**DEVIATION REVIEW
 AND DECISION FORM**

Address of Subject Property (Street Number/Name): Not Available
 Tax Schedule ID(s) #:5500000135
 Legal Description of Property: W2 SEC 9-15-65. EX PT TO RDS
 Subdivision or Project Name Springs East at Waterview, preliminary plan

Section of ECM from Which Deviation is Sought: 2.3.2 Design Standards by Function Classification

Specific Criteria from Which a Deviation is Sought: Minimum centerline curve radius on an Urban Non-Residential Collector

Figure 4

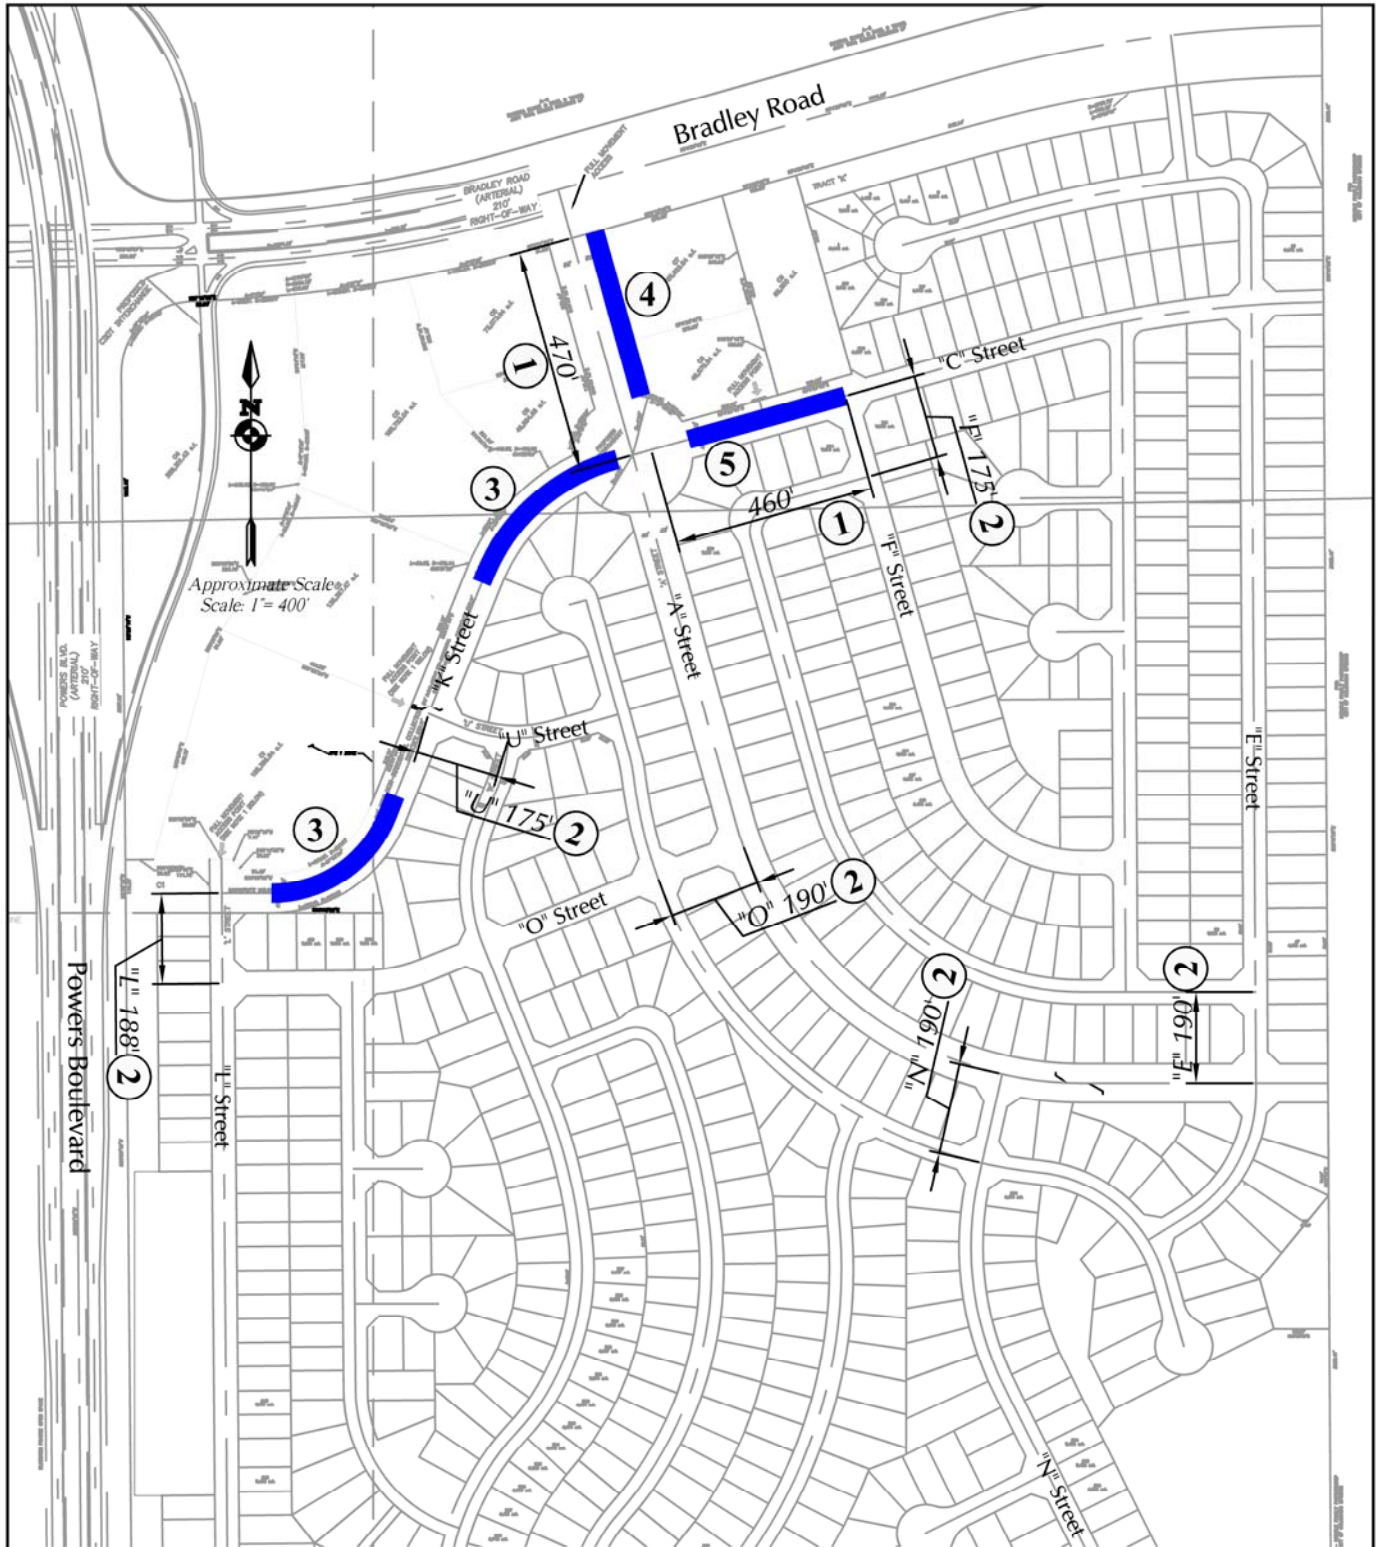
Proposed Nature and Extent of Deviation: The deviation requested is to allow proposed centerline horizontal curve radii of 410' and 260' for two horizontal curves on an Urban Non-Residential Collector - "K" street. These curves are located west of the proposed roundabout.

Reason for the Requested Deviation: Given a combination of factors - the Powers Boulevard access restriction, the requirement to reserve future ROW for a Bradley/Powers grade-separated interchange, no direct commercial access to Bradley Road permitted, and the need to create a viable site (both size and shape) for future commercial development, the need to create perpendicular intersections at Bradley Road/"A Street" and create perpendicular streets at the roundabout itself -- the resulting street layout resulted in the two proposed horizontal curves with radii less than 565 feet.

Comparison of Proposed Deviation to ECM Standard: The proposed centerline curve radii are 155 feet and 305 feet less than the ECM standard of 565'

Applicable Regional or National Standards used as Basis: The Industrial classification in the Colorado Springs Traffic Criteria Manual lists a horizontal alignment radius of 335 feet.

Given the site-specific conditions, the proposed radii will achieve the intended purpose -- to provide access to the commercial site for passenger vehicles and trucks and connections to the residential Urban Local streets. The curve with the 410-foot radii will be on the section of roadway with the higher traffic volume as it occurs prior to the first commercial access; however, the curve is adjacent to the proposed roundabout, so vehicles will be entering the curve at slower speed than if the roundabout were not directly adjacent. Also, the projected ADT will be well below the maximum allowable for a non-residential collector. The other ECM standard cross-sectional elements of the street will remain the same. The proposed 260-foot curve will be adjacent to the end of the street. The street is proposed to tee into L Street on the west side of the site. Therefore, motorists will be approaching a stop condition at the end of the curve. This will require motorists to decelerate to the stop condition.

The 410-foot radius curve is adjacent to the proposed roundabout, so vehicles will be entering the curve at slower speed than if the roundabout were not directly adjacent. Also, the projected ADT will be well below the maximum allowable for a

non-residential collector. The other ECM standard cross-sectional elements of the street will remain the same. The proposed 260-foot curve will be adjacent to the end of the street as the street is proposed to tee into L Street on the west side of the site. Therefore, motorists will be approaching a stop condition at the end of the curve. This will require motorists to decelerate to the stop condition.

LSC recommends an MUTCD "Curve Ahead" sign with a supplemental speed plate indicating "25 mph," followed by a "Stop Ahead" sign be placed upstream of this horizontal curve in the westbound direction, facing westbound traffic. Pavement markings indicating the same would reinforce the signs. Also, low-level landscaping (18" or lower) such as grass, on the inside of the horizontal curve for good line of sight across the inside of the curve. Yellow and black MUTCD curve chevron signs posted on the outside of the curve facing in the westbound approach are also recommended.

Review and Recommendation:
APPROVED by the ECM Administrator

This request has been determined to have met the criteria for approval. A deviation from Section 2.3.2 of ECM is hereby granted based on the justification provided. Comments:

Approval of this deviation is limited to the layout as shown in this preliminary plan. Any changes to this layout or zoning shall void this approval.
